UNITED STATES PATENT AND TRADEMARK OFFICE

APPLICATION NO.	FILING DATE	FIRST NAMED INVENTOR	ATTORNEY DOCKET NO.	CONFIRMATION NO.
10/812,360	03/30/2004	Katsunari Morishima	001309.00058	4113
22907	7590	08/01/2006	EXAMINER	
BANNER & WITCOFF 1001 G STREET N W SUITE 1100 WASHINGTON, DC 20001			MITCHELL, KATHERINE W	
			ART UNIT	PAPER NUMBER
			3677

Office Action Summary	Application No. 10/812,360	Applicant(s) MORISHIMA ET AL.	
	Examiner Katherine W. Mitchell	Art Unit 3677

DETAILED ACTION

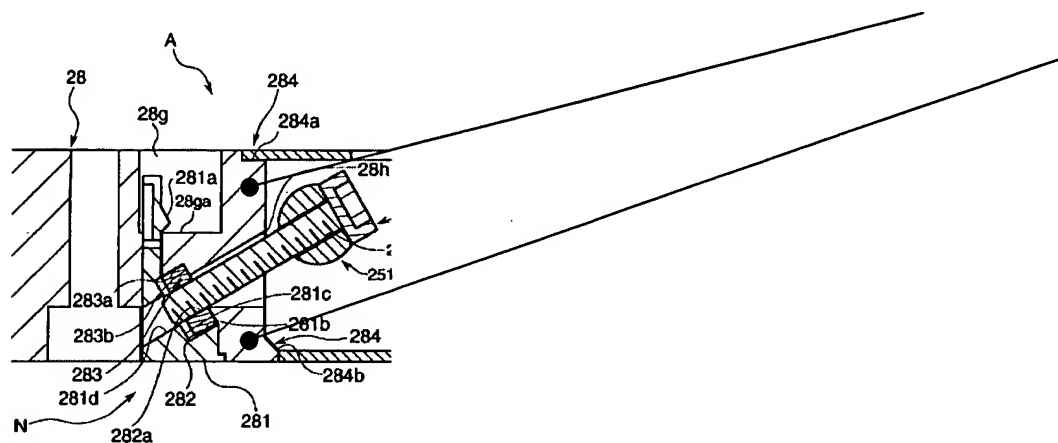
More importantly, examiner noted in both the drawings and the specifications that it was not clear exactly what was the nut retainer 283 and the nut retaining apparatus N. The only body disclosed is connecting body 28, so that is the body, but examiner believes there is much room for argument about what is the nut retainer, what exactly is the nut retaining apparatus, and now what exactly is the end surface of the body. Examiner believes 28 is clearly shown as the body, which comprises the nut retaining apparatus,

and the nut retaining apparatus comprises the nut retainer and nut holder 281, but it is not at all clear to examiner what structurally comprises the nut retaining apparatus, and since the nut retaining apparatus comprises the nut retainer, what structurally comprises the nut retainer. Is the nut retainer the enlarged recess at the end of the bolt hole that holds the nut, (examiner believes this is 28c) or is it the/a structure pointed out below:
